Response to Reviewer 1 Comments

Figure 3(a). Sketch of the structure of the 4UM-120D electric leafy vegetable harvester.

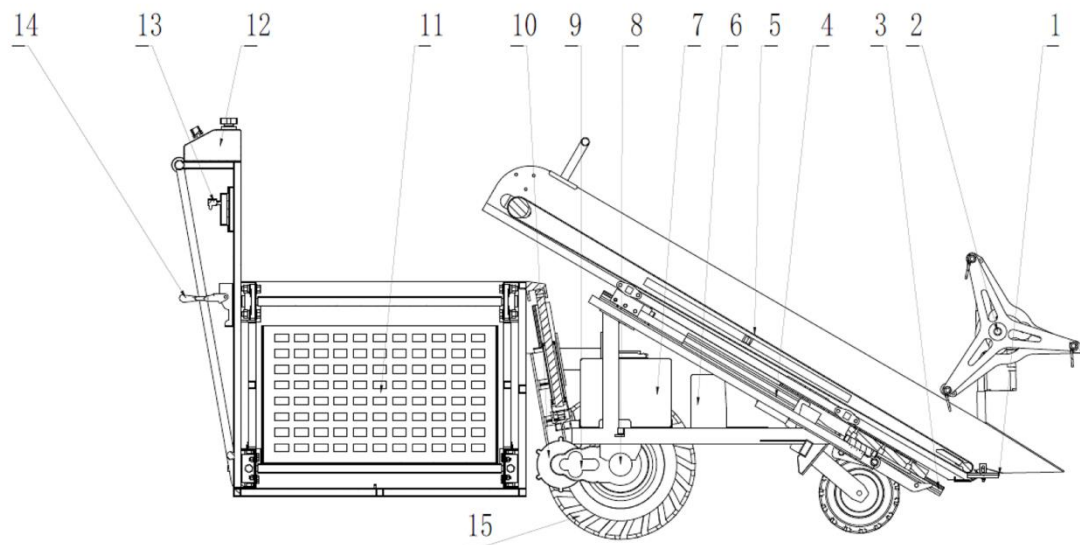
Point 1: I think the resolution of some images should be increased. I also suggest that the font of the texts in the flowcharts should be the same as the main text (See Fig.5, 6..).

Response 1: Thank you for your valuable suggestions. I apologize that some of the images in this manuscript are too low resolution. I also apologize that the font of the texts in the flowcharts are not the same as the main text. The modified figures are shown in Figure 1(a) to Figure 8(a).
